PLACER COUNTY WATER AGENCY

Re: Comments on Bay Delta Conservation Plan, Implementing Agreement and Draft EIR/EIS

SUBJECT: Technical Comments on Bay-Delta Conservation Plan Modeling

Figure 7. NAA-LLT and Alt 4-LLT Simulated Nimbus Release

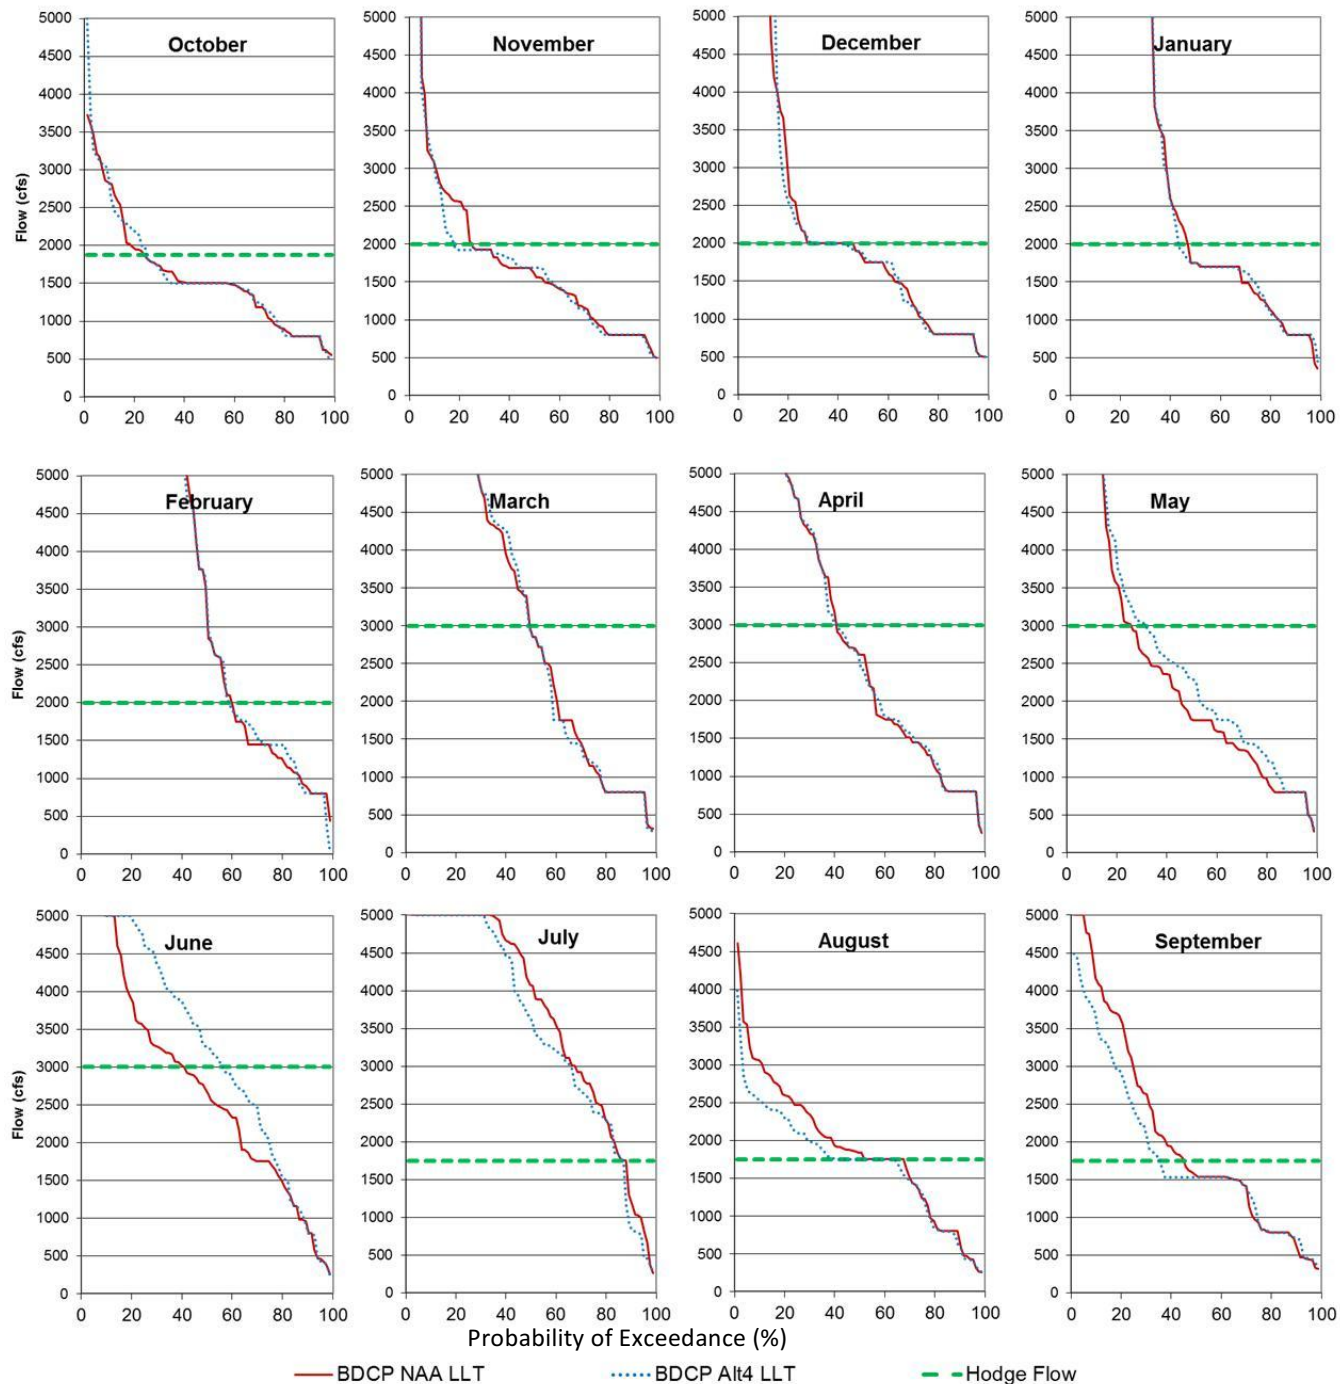
Figure 7 and Figure 8 contain comparisons of simulated monthly flow at Nimbus and H Street for the NAA-LLT and Alt4-LLT scenarios. Results show that under the Alt4-LLT American River flow is higher in the months of May and June, and lower in July, August, and September. Higher releases in May and June drive changes in Folsom storage and water surface elevation seen in previous figures. Likewise, lower releases from July through September bring simulated end-of-September storage between the baseline and with-Project scenarios closer. BDCP modeling shows a higher probability of Lower American River flows being above Hodge Flows in May and June and a higher probability of flows being below Hodge Flows in July, August, and September. When Nimbus releases are below Hodge Flows, diversion limitations under the City of Sacramento's American River water right permits for the Fairbairn Water Treatment Plant on the American River constrain the amount of water available to divert. The changes in American River flows will affect the location of the City of Sacramento's diversion, but this is not reflected in the BDCP modeling. There are also limitations on the City's Sacramento River diversion capability, which could interfere with any such shift in the location of diversions, and hence reduce the supply available to the City. This is not reflected in the BDCP modeling. In the Alt 4-LLT the City of Sacramento will be able to divert more water from the American River at Fairbairn during May and June and less during August and September.

Figure 8. NAA-LLT and Alt 4-LLT Simulated H Street Flow

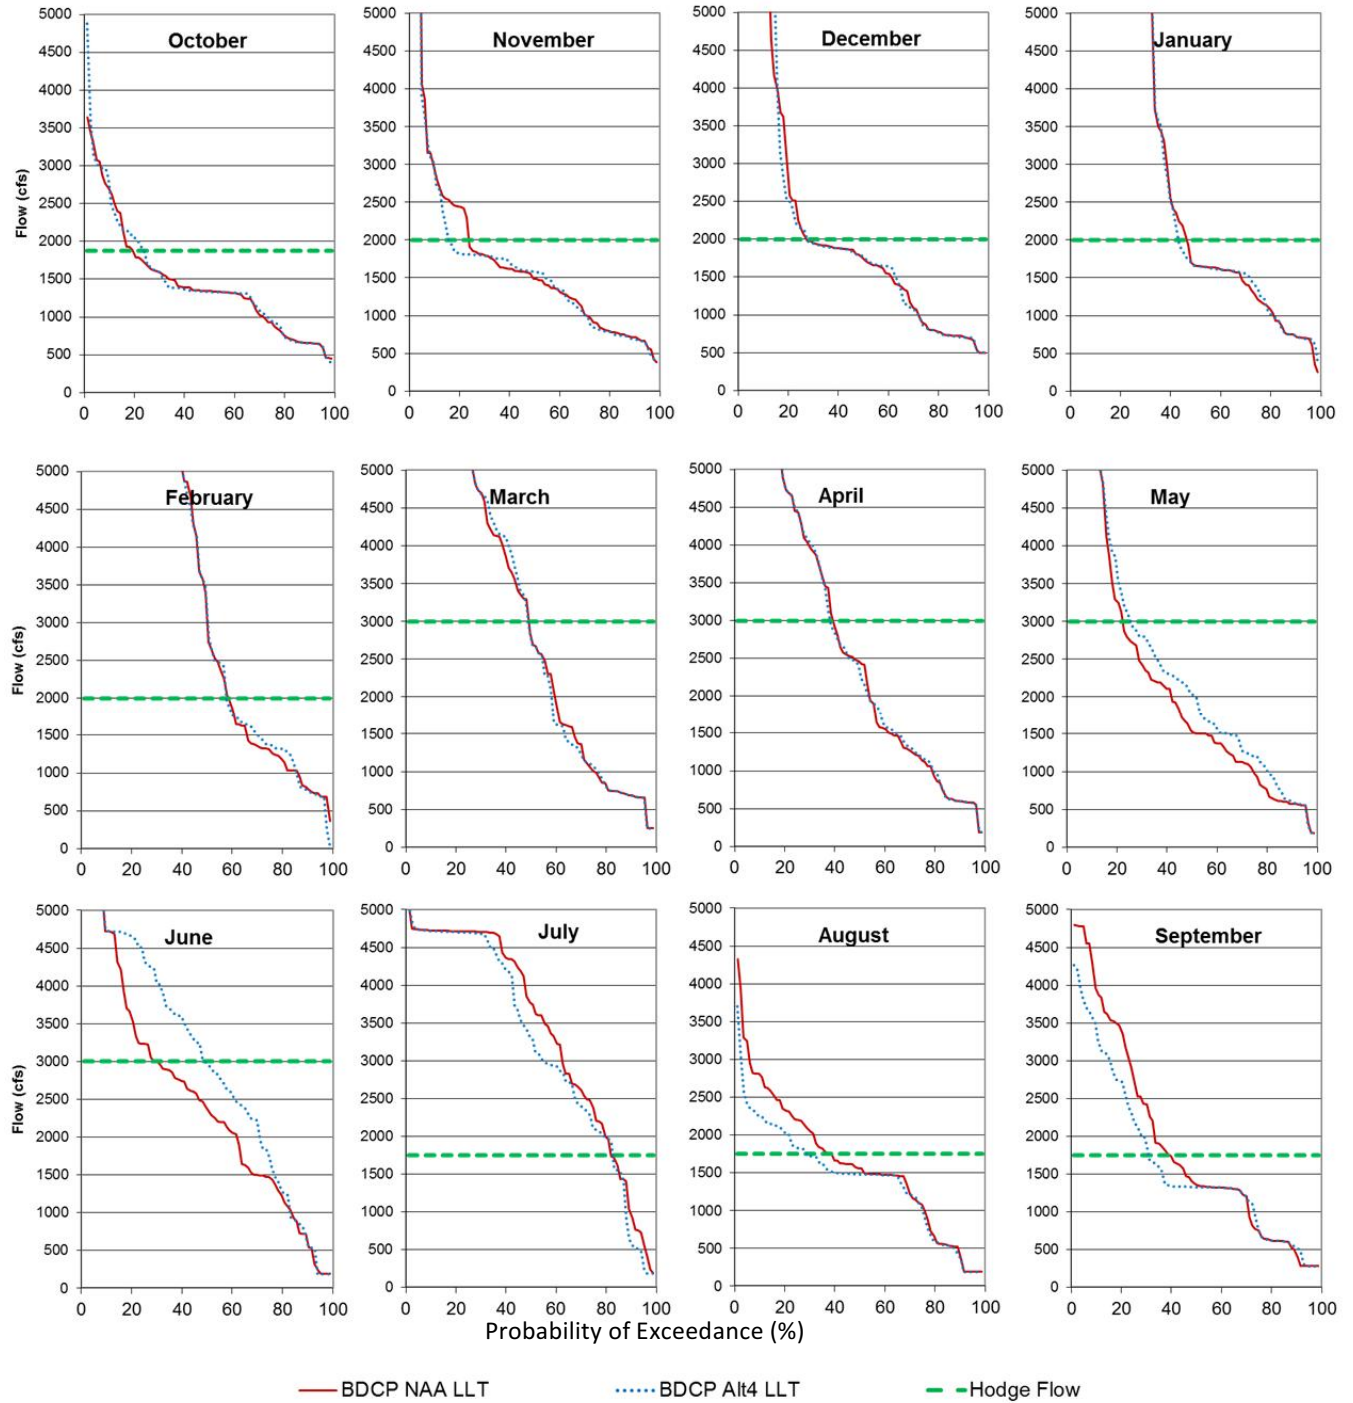
Flow in the lower American River at H Street drops below 500 cfs in both the NAA-LLT and Alt4-LLT. This is critical for the City of Sacramento because their ability to divert water from the American River is affected when flow at H Street falls below 500 cfs due to the potential for pump cavitation. There are times when American River at H Street falls below 500 cfs more often in Alt 4-LLT than in the NAA-LLT. Water availability to the City of Sacramento, including under its settlement contract with Reclamation¹⁴, would be curtailed or eliminated on the American River when water levels in Folsom Reservoir drop below to dead pool level of 90,000 AF.

Figure 9. NAA-LLT and Alt 4-LLT Simulated Sacramento River Flow at the American River

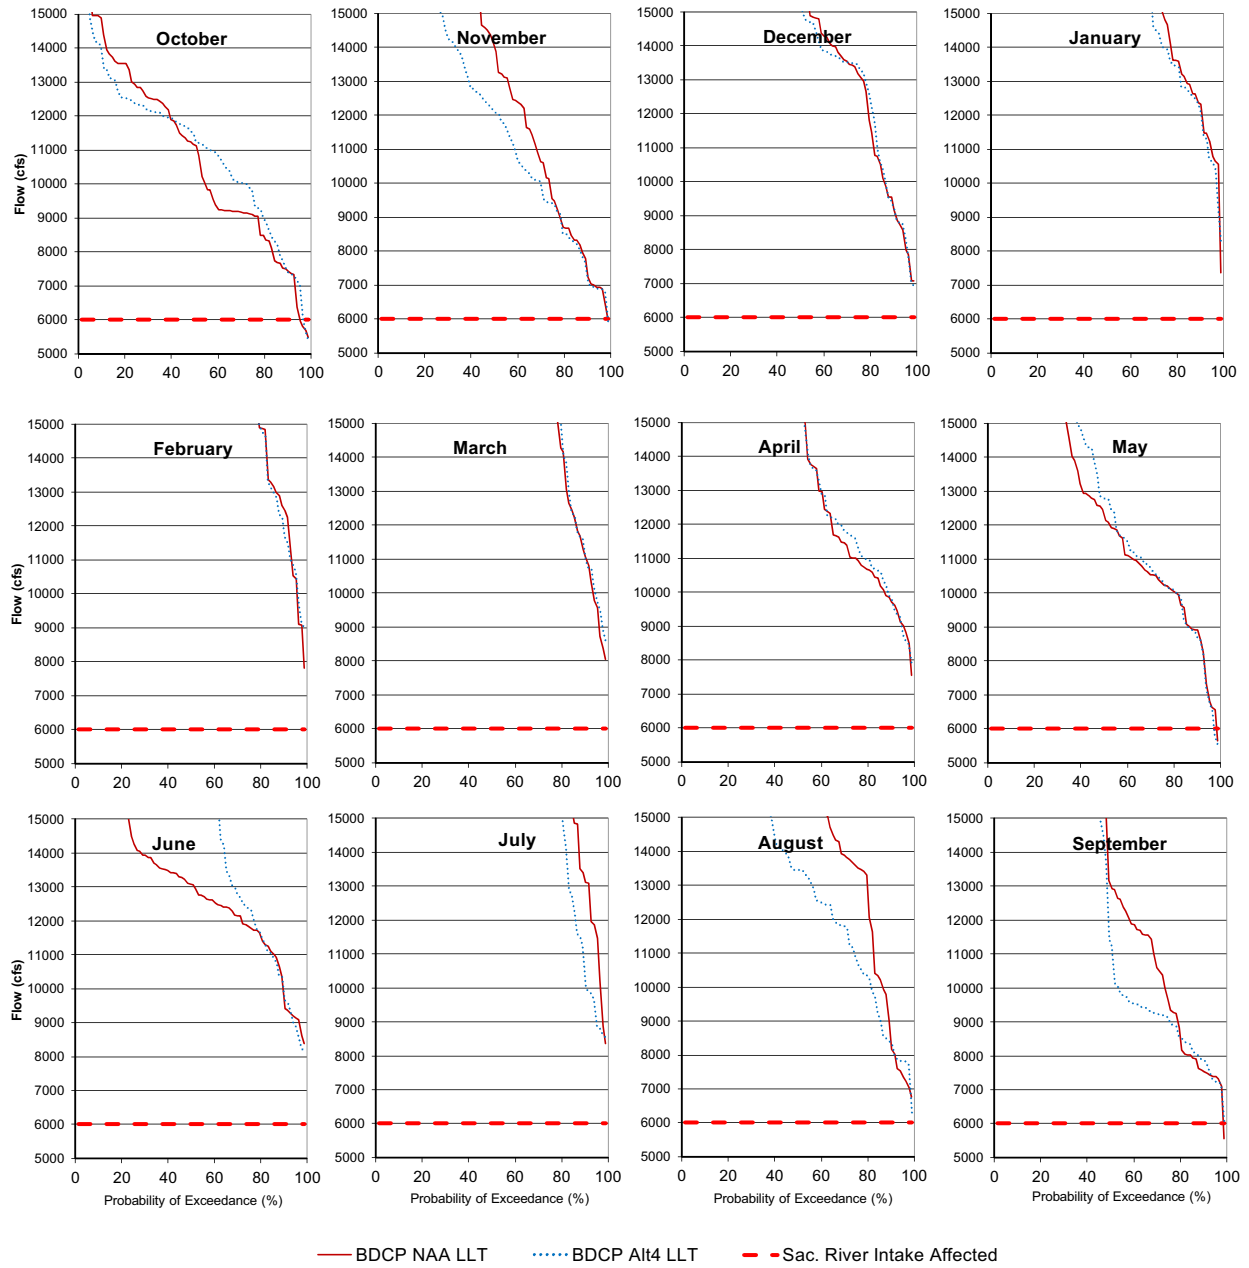
Figure 9 contains comparisons of simulated monthly flow in the Sacramento River at the confluence of the American River for the NAA-LLT and Alt4-LLT scenarios. When Sacramento River elevation falls below two feet above sea level (NGVD 1929) the City of Sacramento's intake structure capacity is reduced. Elevation 2.0 occurs when the flow rate is between approximately 5,000 cfs and 9,000 cfs and depends on tidal variation. Moreover, flow rates below 5,000 cfs may result in cavitation or vortexing, causing significant pump damage. Based on CalSim II modeling results, the frequency of the Sacramento River falling below 6,000 cfs is similar in the NAA-LLT and Alt4-LLT.

Figure 10. CVP North of Delta M&I Water Service Contract Allocation

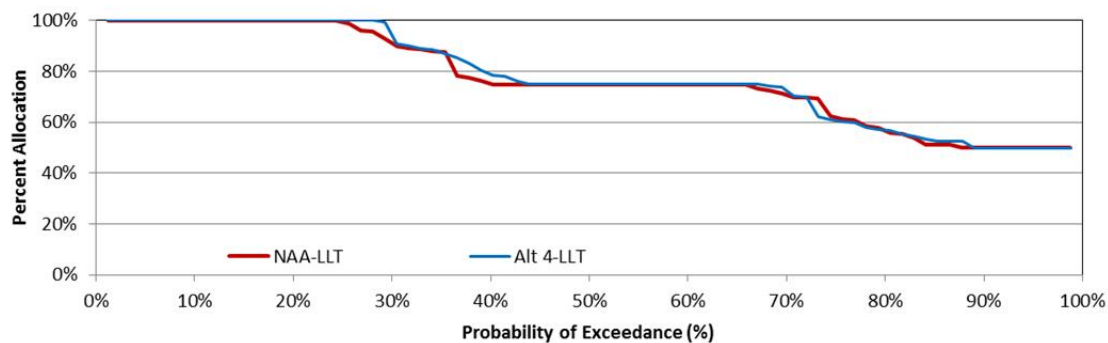
Figure 10 is an exceedance probability plot of CVP North of Delta M&I Water Service Contract Allocation for the NAA-LLT and Alt4-LLT. Changes in these allocations would affect the numerous CVP water-service contractors in the American River Basin, including the cities of Folsom and Roseville, Placer County Water Agency, SMUD and Sacramento County Water Agency. Average annual allocation to CVP M&I water service contractors is about 78% and increases by about one half of one percent in Alt 4-LLT compared to NAA-LLT. Although allocation never falls below 50%, deliveries are not always met due to low reservoir and river flows

Figure 5a. Summer (July - October) Monthly Mean End-of-Month of Storage Folsom Reservoir Storage (TAF) under the Existing Condition, No Action Alternative, and Preferred Alternative (Alternative 4).

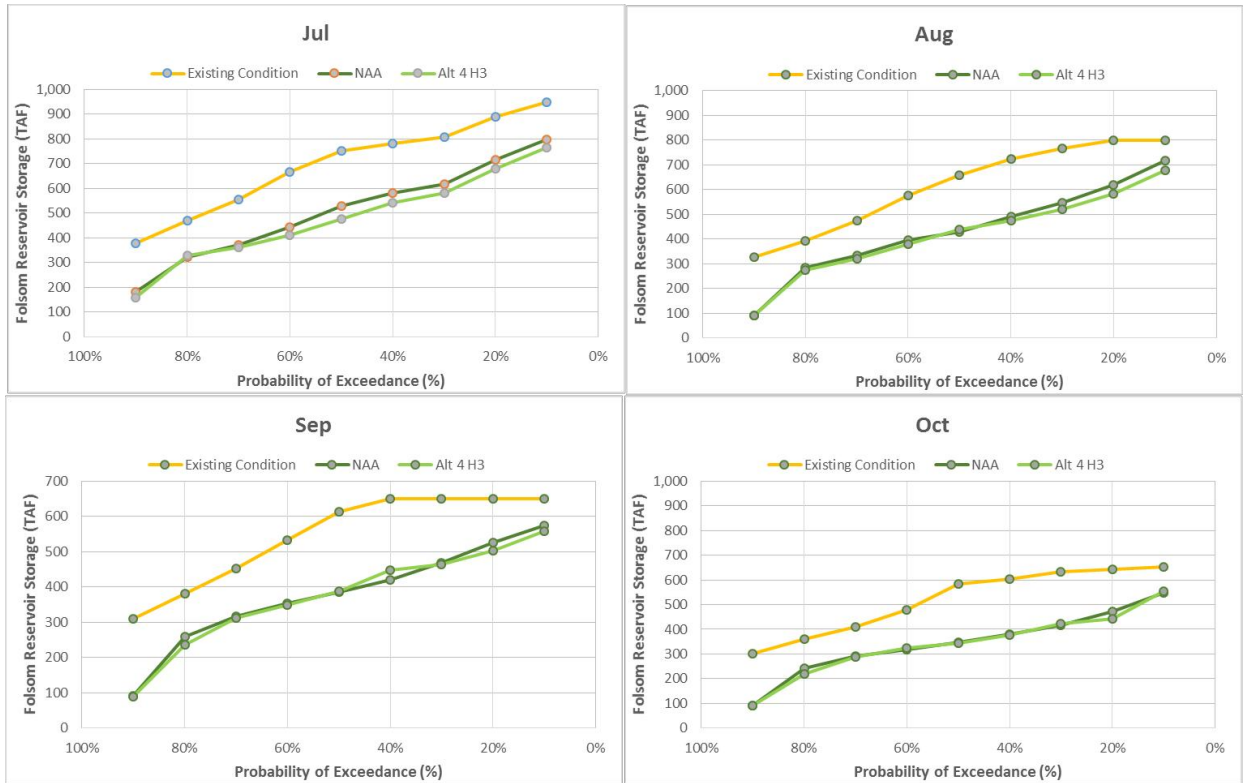
The operation of the CVP/SWP as modeled in the NAA with the sea level rise, climate change, and future demand assumptions results in much lower Folsom Reservoir storage elevations compared to existing conditions (Figures 5a and b) and greatly increased LAR water temperature. The frequency of Folsom Reservoir being at low storage levels (e.g., <350 thousand acre-feet [TAF]) would increase substantially in July and August under the NAA compared to existing conditions (increases from about 10% of the time under existing conditions to about 30% of the time under the NAA) (Figure 5a). In critical years, mean monthly

Figure 6. Folsom Reservoir Storage (TAF) in Relation to ATSP Temperature Schedule¹. Higher ATSP Schedules Correspond to Warmer Summer Temperatures. All Schedules Larger than 55 Exceed Summer Temperatures of 70°F.

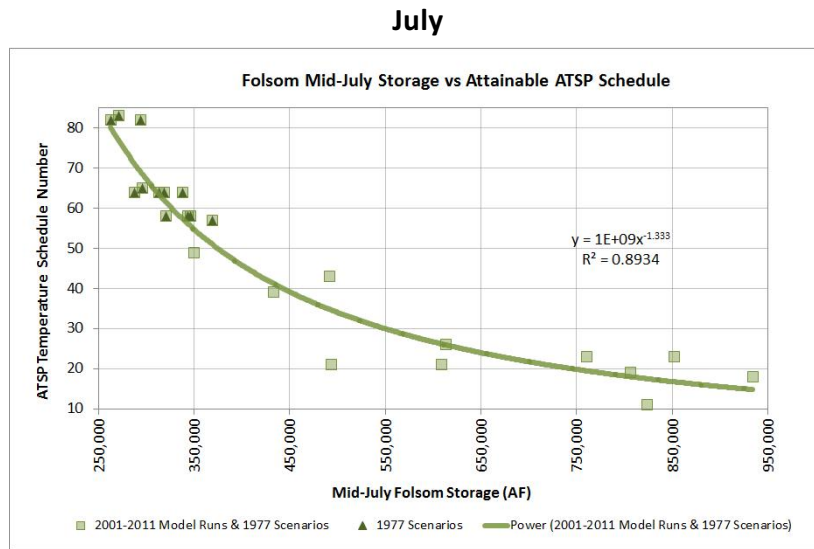
Higher American River summer temperature schedules occur when Folsom Reservoir storage drops, particularly as storage falls below 350 TAF in July. Figure 6 shows a relationship between the Folsom Reservoir storage in July and LAR water temperature schedules². Figure 7 shows relatively large increases in fall water temperature below Nimbus Dam at low Folsom Reservoir water levels as reported in the BDCP EIR/EIS (and the associated Folsom Reservoir storage) under the NAA operations. These changes are most pronounced in drier years.
